Surfside Multi-Family Final Plat

Subject: Final Plat – Surfside Drive Multifamily – Technical Review Committee Comments for December 15, 2022 TRC Meeting

**RE : Surfside Quadraplex Final Plat – 1602 Surfside Drive
TRC No. 22-09000010**

RE: Ocean Residences at Surfside Plat PRM Inspection - Review # 2

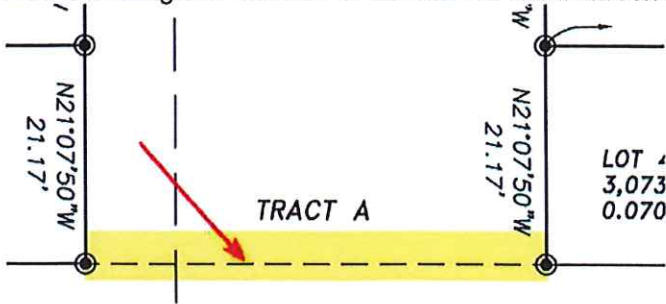
1. Add a section to cover page for reviewing surveyor signature. 177.081(1)
Frank Veldhuis
Professional Surveyor and Mapper
Certificate number 6582
2. All easements must be dimensioned. There is an east/west jog in the access and utility easements on lots 2 and 4 that does not have a bearing and length. 177.091(16)

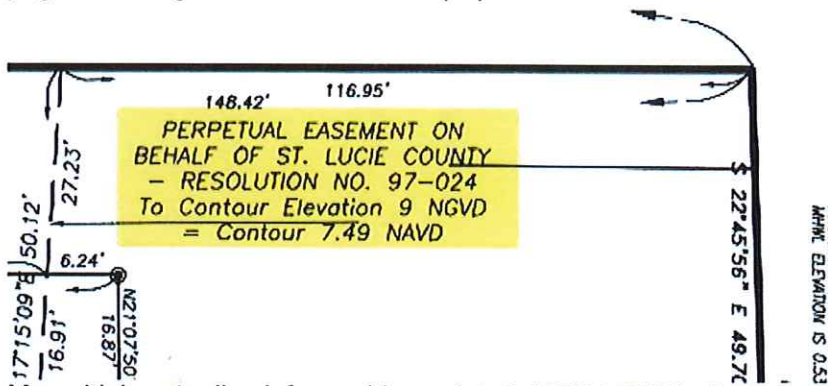
3. Add a bearing and distance to the dashed line between lots 4 and 4A. 177.091(19)

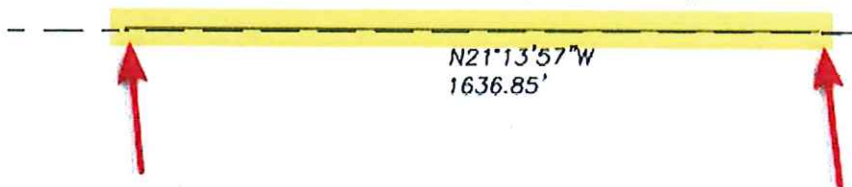
7. Mean high water line info provide on date is "15.31.2019", please revise.
